Procure and Form Change Request

Document Number: SP 21136 Revision No. 9 Change No. 15

Document Title: Safety Injection and CTMT Spary System Valves Operational Readiness Test

To include instructions that will maintain the containment sump suction piping full.

SKETCH 1

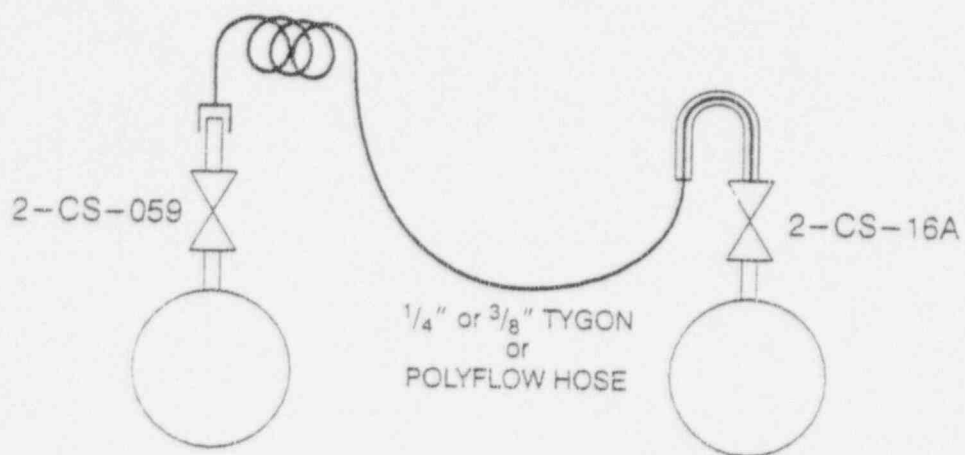
7.20.4 Refer To Sketch 1 (Page 546) and CONNECT a small diameter tygon hose to the vent line downstream of "A' SIS Suction Header Vent," 2-CS-059.

7.20.5 Refer To Sketch 1 (Page 546) and INSERT the free end of the tube connected to the vent line downstream of "A' SIS Suction Header Vent," 2-CS-059 into vent line downstream of "A' SIS Suction Header Test Connection," 2-CS-16A.

SKETCH 2

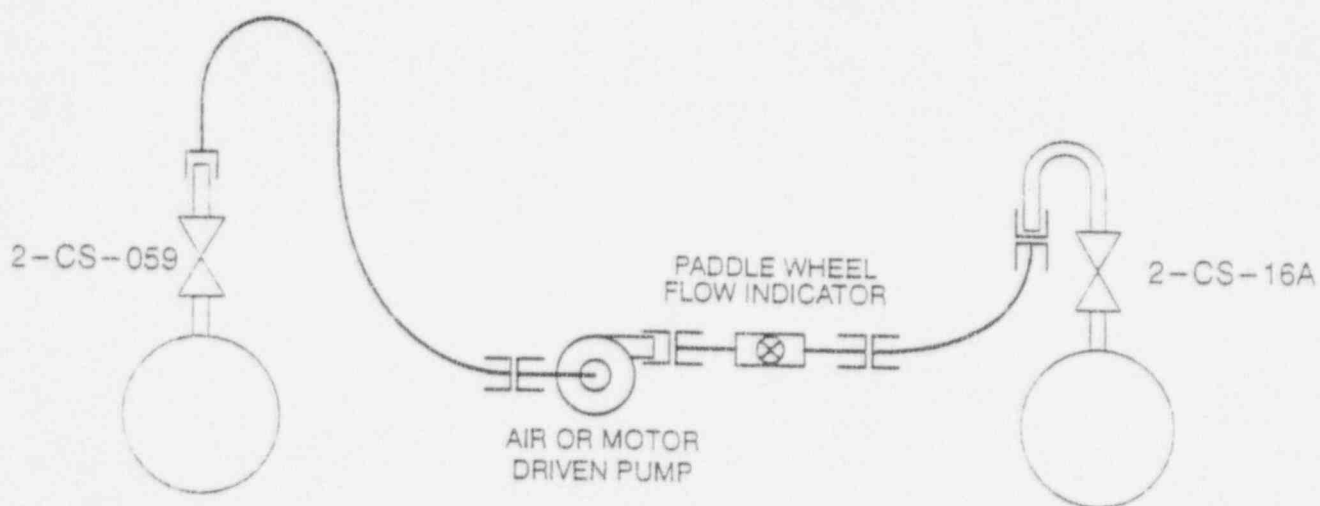
- 7.20.11 CLOSE "A' SIS Suction Header Test Connection," 2-CS-16A.
- 7.20.12 Refer To Sketch 2 (Page 54) and PERFORM the following:
- a. CONNECT the suction of a small air or electric driven pump (provided by Unit 2 Technical Support) to the vent line downstream of "A' SIS Suction Header Vent," 2-CS-059.

- b. CONNECT the pump discharge to a paddle wheel flow indicator.
 - c. DIRECT the discharge of the paddle wheel flow indicator to a suitable container or drain.

- d. FLUSH AND VENT the air from the hoses, pump and paddle wheel flow indicator by opening "A' SIS Suction Header Vent," 2-CS-059 and operating the pump as necessary.

- e. CONNECT the outlet of the paddle wheel flow indicator to "A' SIS Suction Header Test Connection," 2-CS-16A.
- 7.20.13 OPEN "A' SIS Suction Header Vent," 2-CS-059 and "A' SIS Suction Header Test Connection," 2-CS-16A.

SKETCH 3

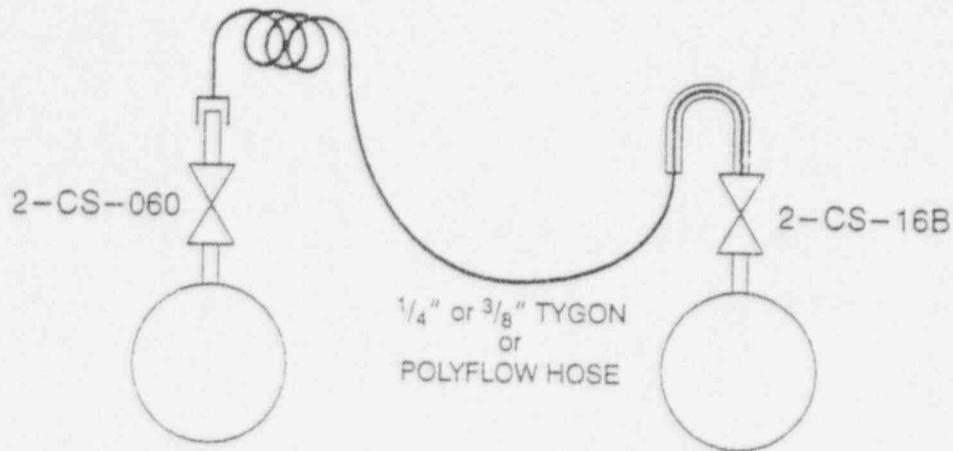
7.21.4 Refer To Sketch 3 (Page 56e) and CONNECT a small diameter tygon hose to the vent line downstream of "SIS Suction 'B' Header Vent," 2-CS-060.

7.21.5 Refer To Sketch 3 (Page 56e) and INSERT the free end of the tube connected to the vent line downstream of "SIS Suction 'B' Header Vent," 2-CS-060 into vent line downstream of "'B' SIS Suction Header Test Connection," 2-CS-16B.

SKETCH 4

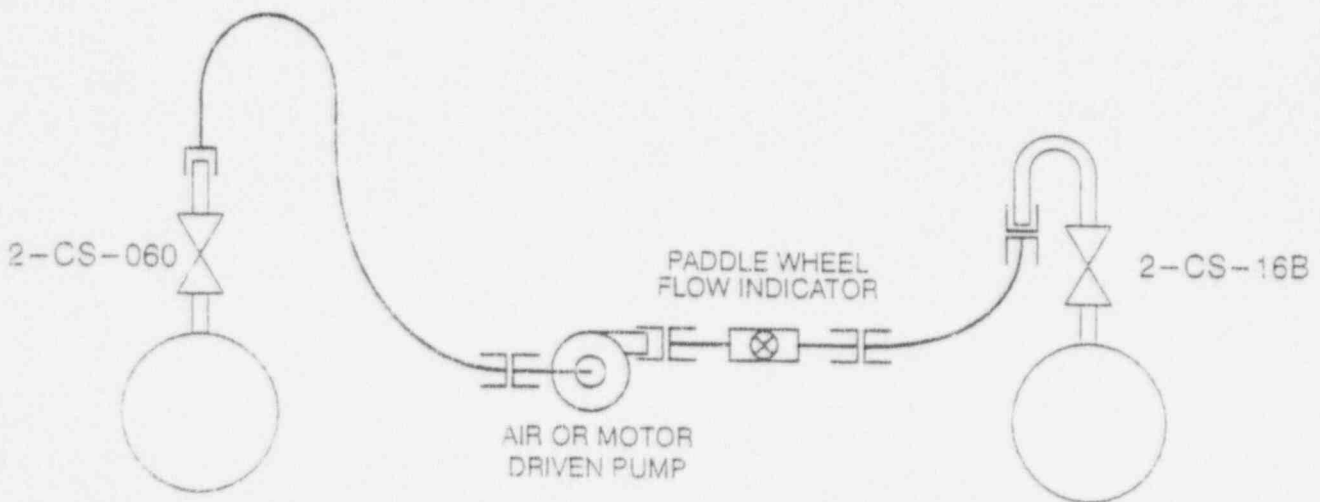
- 7.21.11 CLOSE "'B' SIS Suction Header Test Connection," 2-CS-16B.
- 7.21.12 Refer To Sketch 4 (Page 56) and PERFORM the following:
- CONNECT the suction of a small air or electric driven pump (provided by Unit 2 Technical Support) to the vent line downstream of "SIS Suction 'B' Header Vent," 2-CS-060.

- CONNECT the pump discharge to a paddle wheel flow indicator.
 - DIRECT the discharge of the paddle wheel flow indicator to a suitable container or drain.

- FLUSH AND VENT the air from the hoses, pump and paddle wheel flow indicator by opening "SIS Suction 'B' Header Vent," 2-CS-060 and operating the pump as necessary.

- CONNECT the outlet of the paddle wheel flow indicator to "'B' SIS Suction Header Test Connection," 2-CS-16B.
- 7.21.13 OPEN "SIS Suction 'B' Header Vent," 2-CS-060 and "'B' SIS Suction Header Test Connection," 2-CS-16B.
